PROJECT TITLE: K-Mart Shopping Center ZONE ATLAS/DRN FILE #: K12/D21LEGAL DESCRIPTION: Tract C-1 Milne Addition, and Vacated Isleta Drain ROWCITY ADDRESS: 4208 Central Ave SWENGINEERING FIRM: Lovelady & Associates CONTACT: Frank LoveladyADDRESS: 7408 Morrow Ave. NE 87110 PHONE: 883-7973

RE: REVISED GRADING AND DRAINAGE PLAN SUBMITTAL OF K-MART SHOPPING
CENTER, RECEIVED SEPTEMBER 22, 1988, FOR GRADING/PAVING PERMIT
APPROVAL. (K-12/D21)

RE: GRADING & DRAINAGE PLAN FOR REPAVING ON K-MART SHOPPING CENTER
RECEIVED AUGUST 8, 1988 FOR PAVING PERMIT APPROVAL (K-12/D21)

GRADING AND DRAINAGE PLAN
FOR REPAVING AND EXPANDING EXISTING PARKING LOT
K-MART SHOPPING CENTER
CENTRAL AVENUE & ATRISCO DRIVE
ALBUQUERQUE, NEW MEXICO

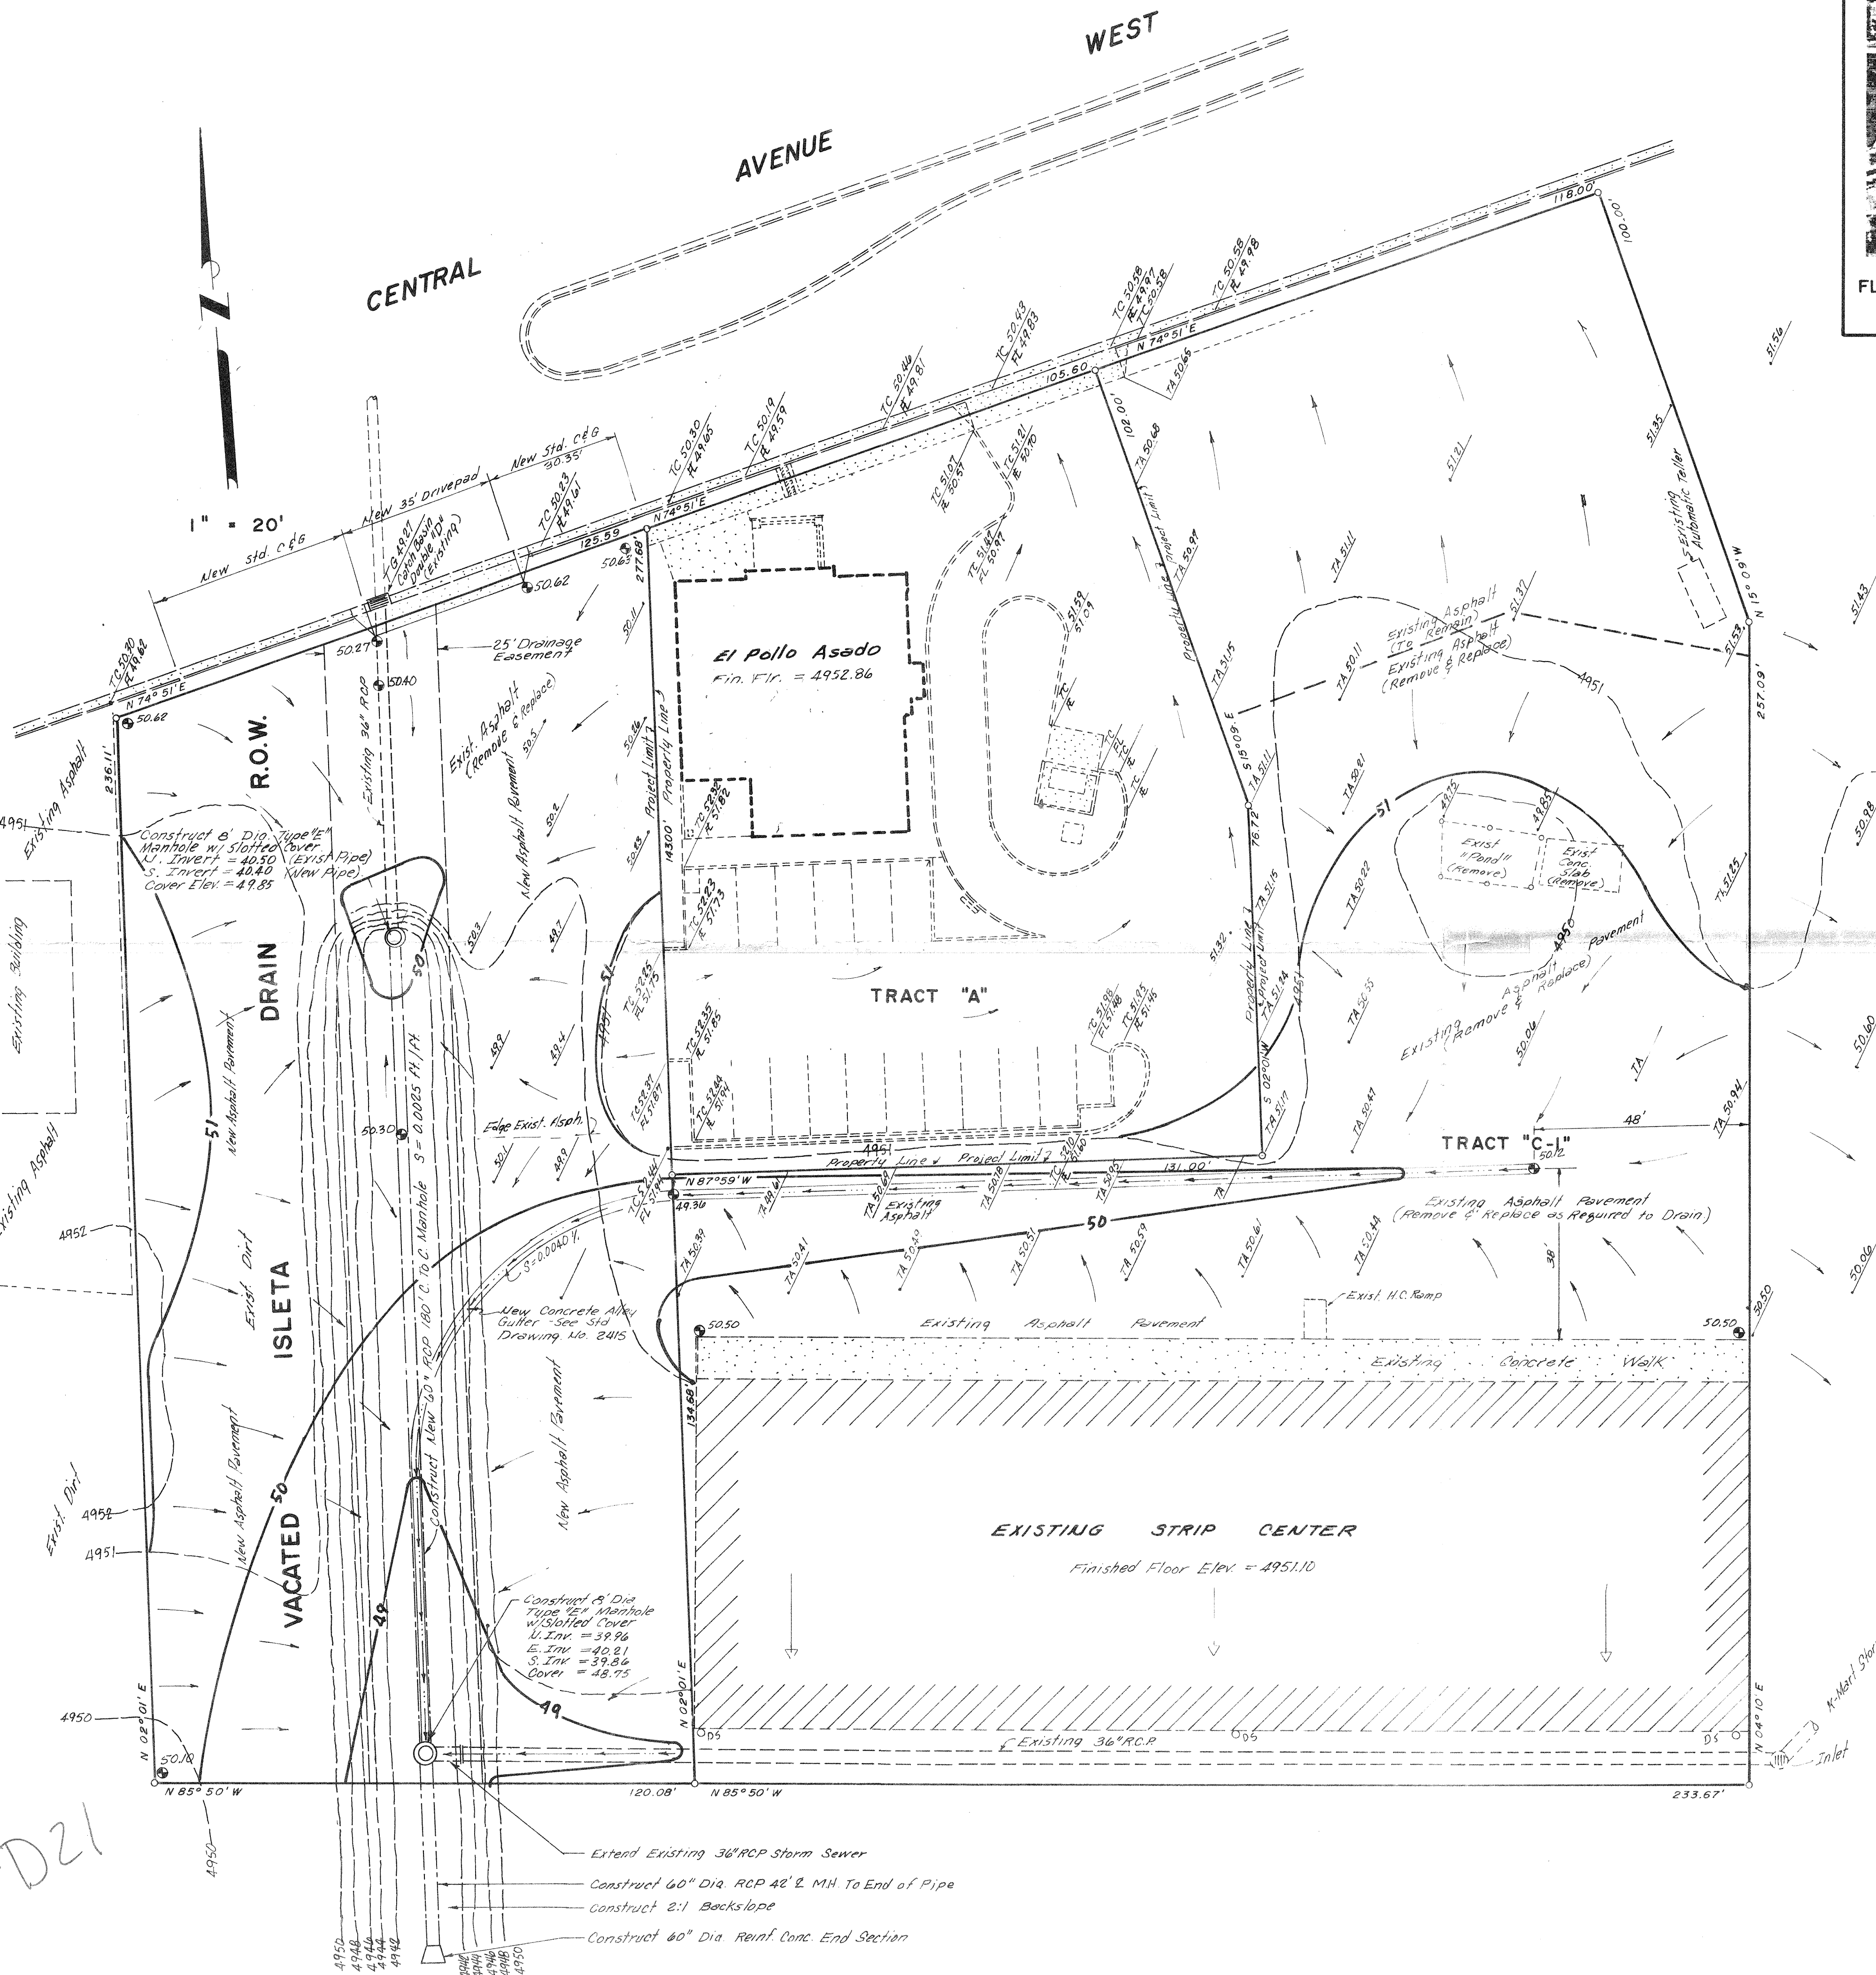
1. The existing elevations along Central Avenue and on the existing asphalt near the Isleta Drain are not consistent with those shown on the construction plans previously submitted for the Isleta Drain Extension project. Which plans are correct?
2. Is a concrete valley gutter required across Tract C-1 and the Isleta Drain right-of-way? If so, label it as such and provide a typical cross section.
3. Show the required slope of the swale or valley gutter that outlets into the inlet on the 6' diameter manhole.
4. Provide staking dimension to the upstream end of swale, where the spot elevation is shown as elevation 50.12.
5. Label the type of catch basin at the proposed drive pad into Central Avenue.
6. Is the existing concrete slab next to the existing "pond" to be removed? The notes just say existing asphalt to be removed and replaced.

The above referenced submittal dated September 20, 1988, is approved for
Grading and Paving by the contractor in accordance with these plans.
Prior to actual construction, all requirements of the M.R.G.C.D. must
have been met, with the new 60" RCP in place and accepted by M.R.G.C.D.
